Access Compliance Report Public Rights-of-Way (Pedestrian Signals)

Main Street: **NEWLAND_ST** Cross Street: **MADISON_AVE** Location: **NE**

ADA ID: **SGRK210929124713** Signal Type: **One Push Button-Non APS** Overall Compliance: **No** Severity Scores: **BTN 1: 35** **BTN 2: N/A** **No BTN: N/A**

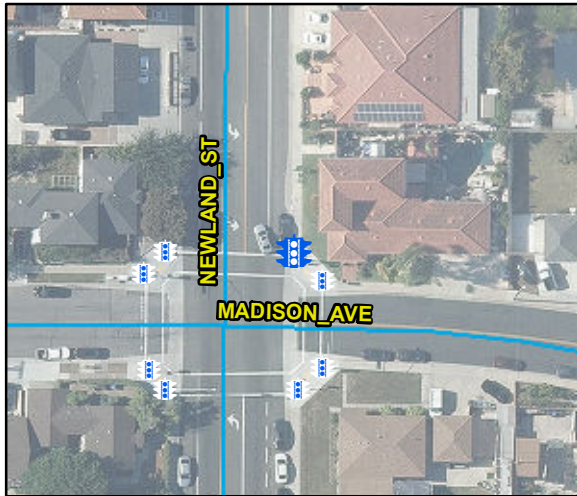
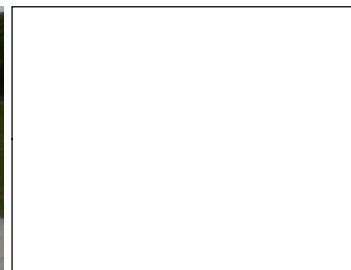
OC Std/PROW: **R404.2, R404.3, MUTCD 4e.08**

Possible Solutions: Replace Signal Push Button With APS Button. Remove and Replace Clear Space.
